ARCO Products Company  
2000 Alameda de las Pulgas  
Mailing Address: Box 5811  
San Mateo, California 94402  
Telephone 415 571 2400

Re: ACHCSA Letter of 10/7/91 regarding ARCO Station 276 at 10600 MacArthur Boulevard, Oakland, California.

This letter is an attempt to clarify questions raised in your letter concerning existing off site vapor extraction system and the proposed on site vapor extraction system at the subject site. Items you requested clarification on will be addressed in the order listed in your letter.

FIGURE :  
1

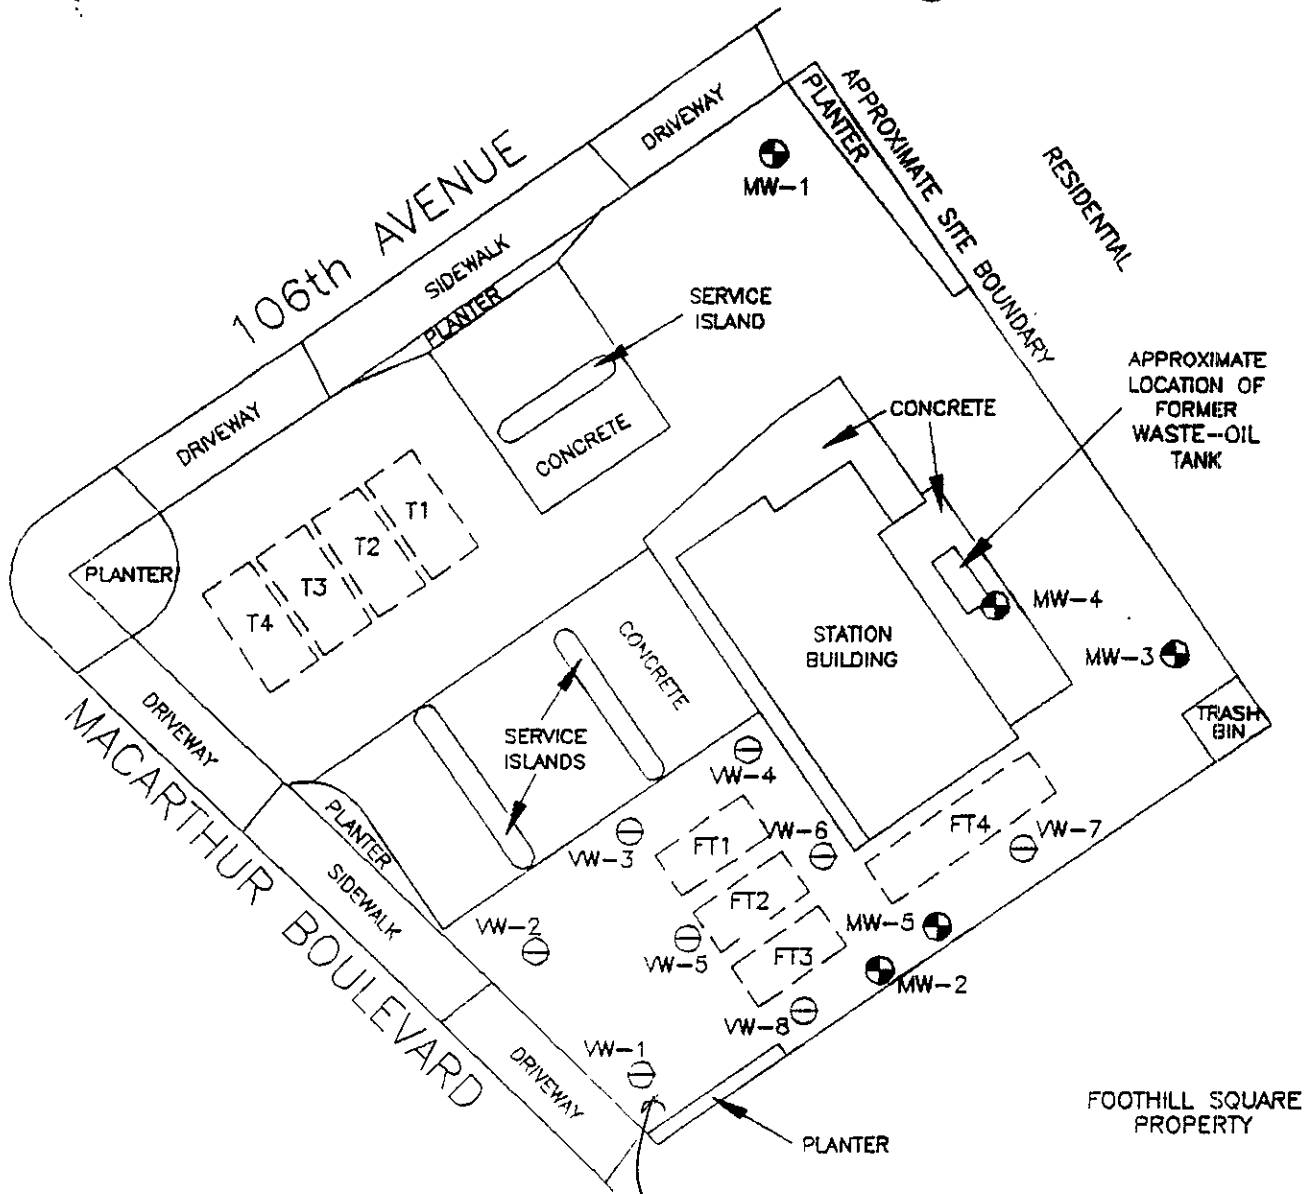
- 1. You are requested to provide a map indicating the locations of the existing vapor extraction wells also indicating the locations of the proposed vapor and extraction wells. Please also provide a plumbing schematic indicating the locations of all piping connections into and out of the Remed-cat treatment system.**

Figure 1 is a map showing locations of existing vapor extraction wells and probes. Figure 2 is a map showing locations of proposed vapor extraction wells as depicted in the Addendum One to Work Plan (RESNA, June 27, 1991).
